# complete guitar wiring: erratum

## kill switches

### correction

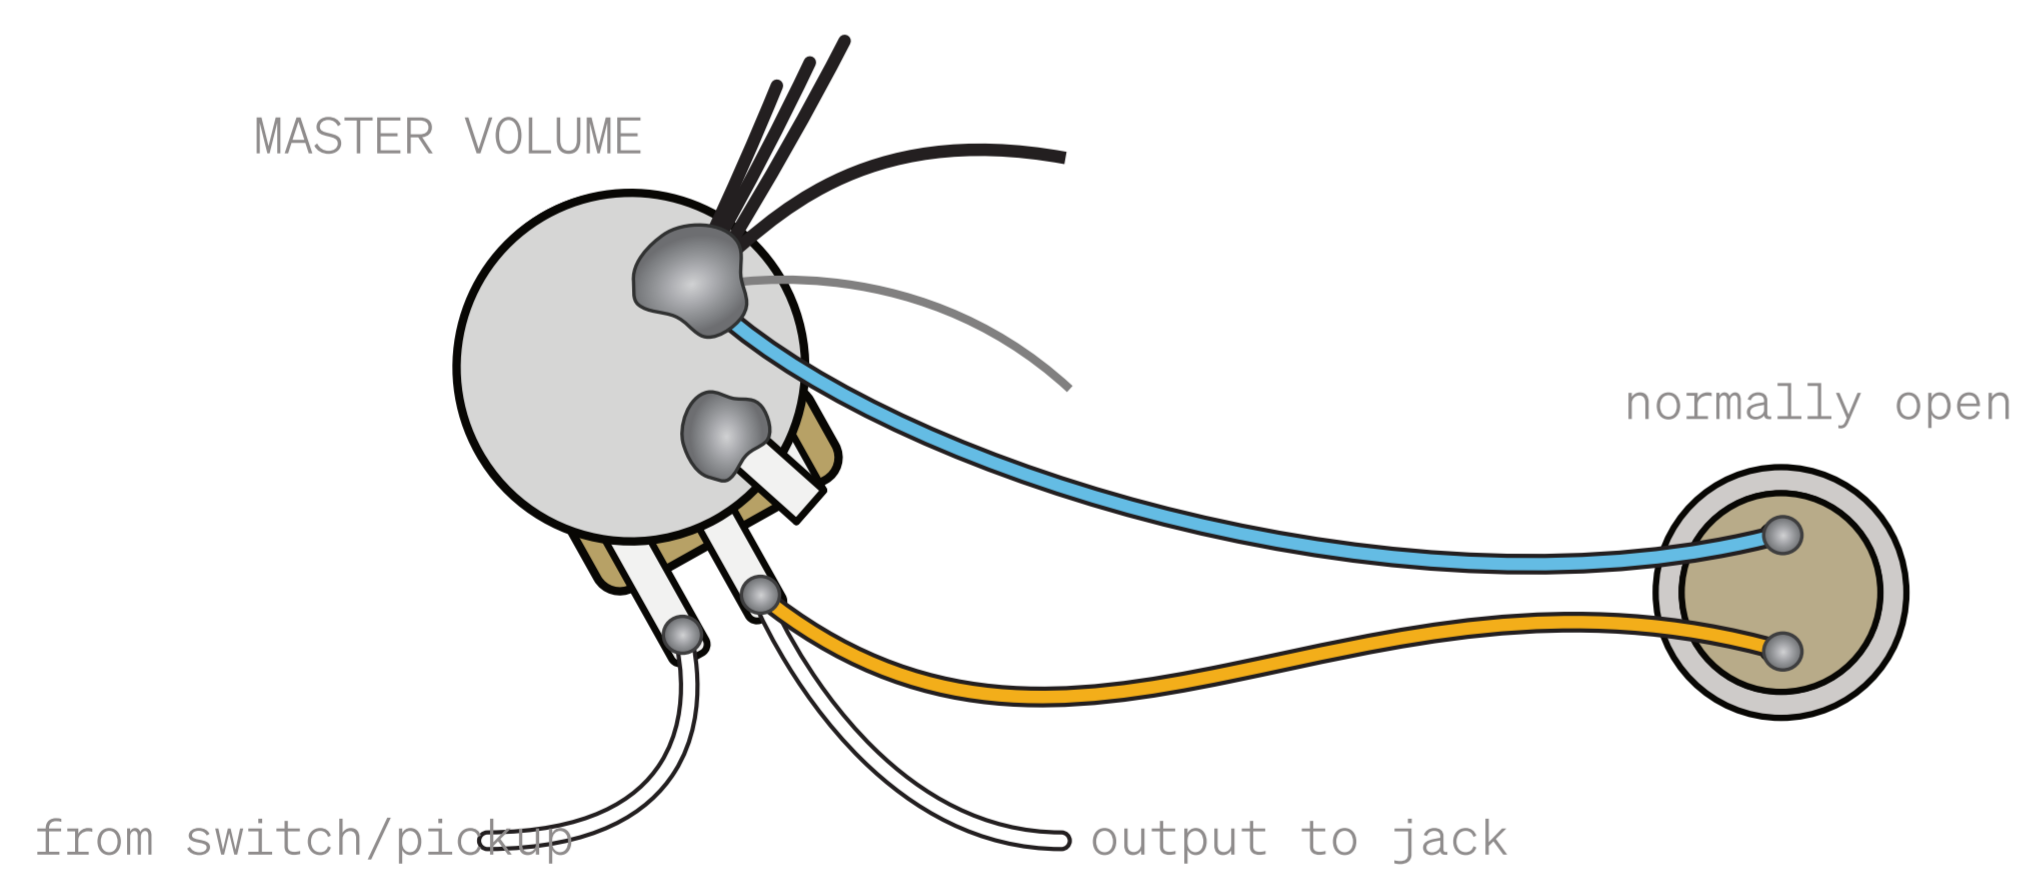
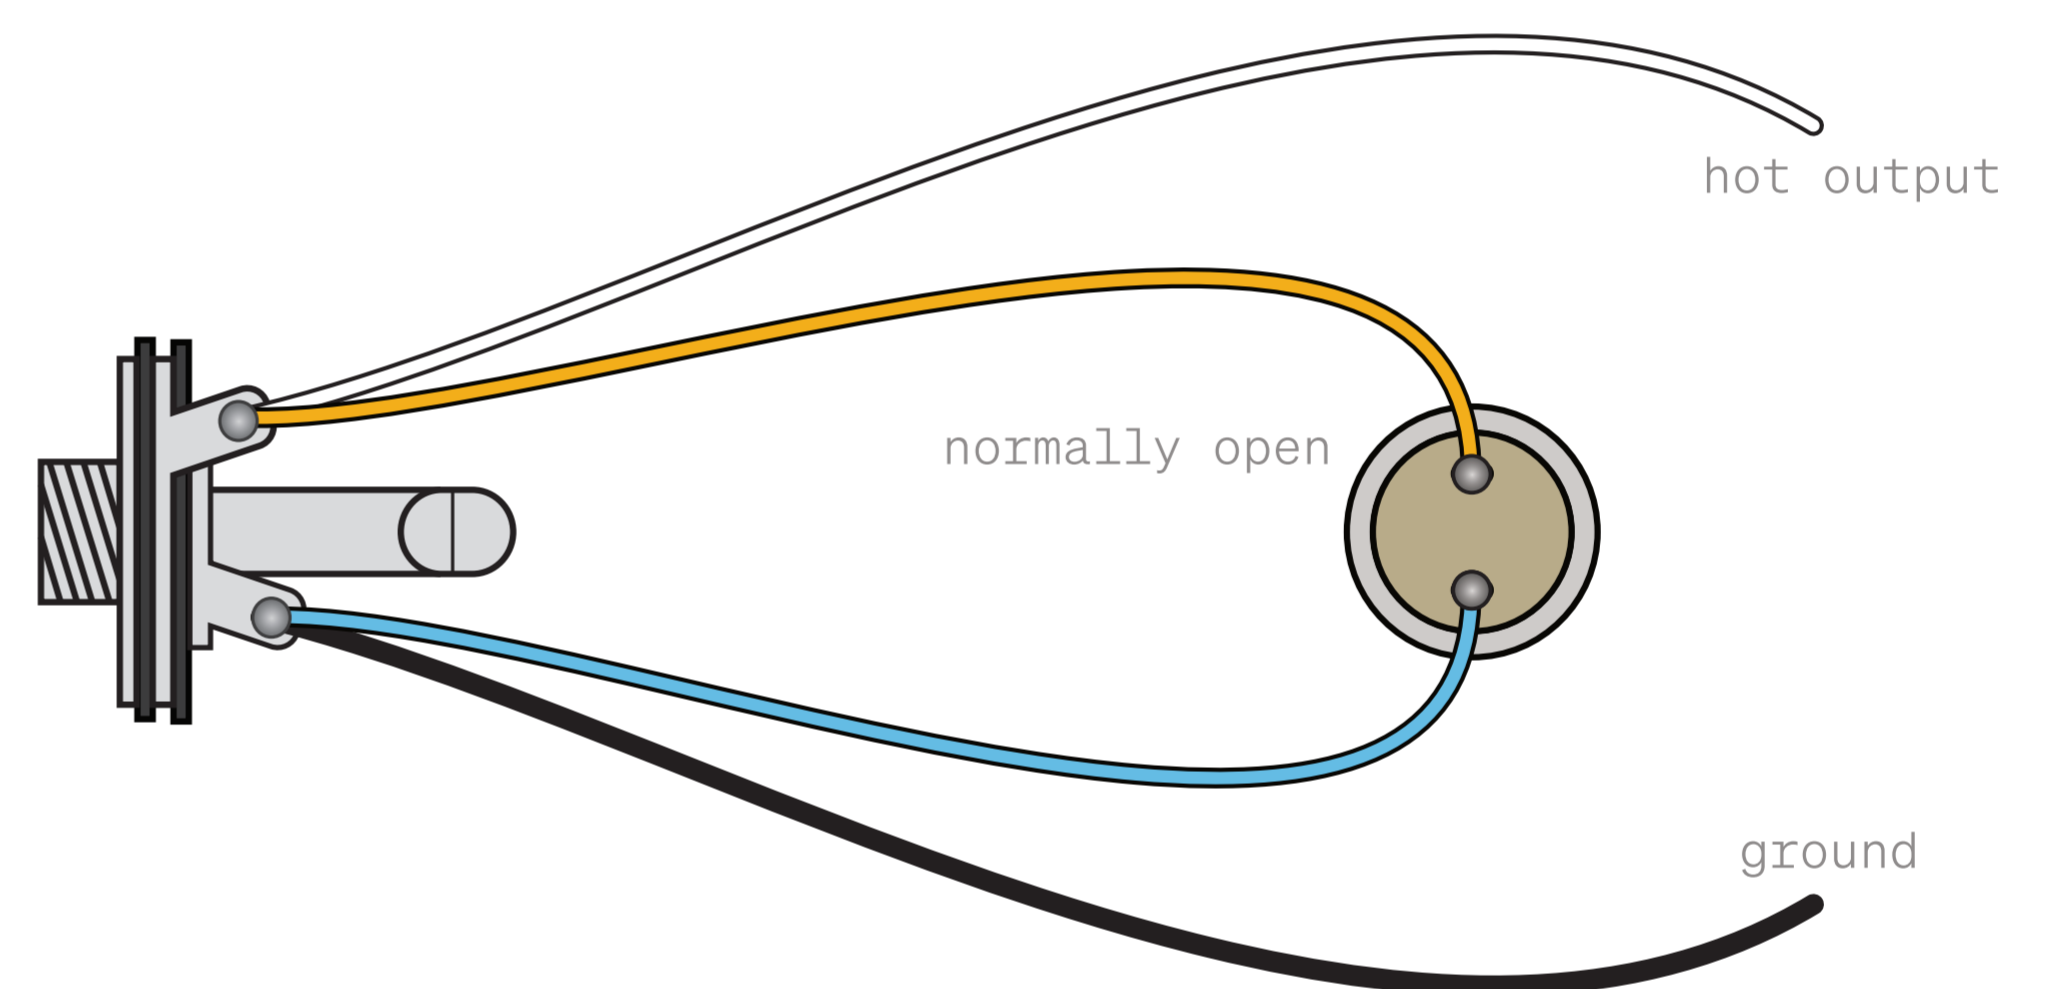
Page 319. The switches in each diagram were correctly listed as normally-open or normally-closed but the label pointing to each diagram incorrectly flipped these switch types.

← **Normally-closed kill switch:** Interrupts the main hot output wire on its way to the jack.

→ **Normally-open kill switch:** Bridges the hot connection at the jack to the ground connection when engaged.

← **Normally-open kill switch:** Bridges the output from the master volume control to ground when engaged.
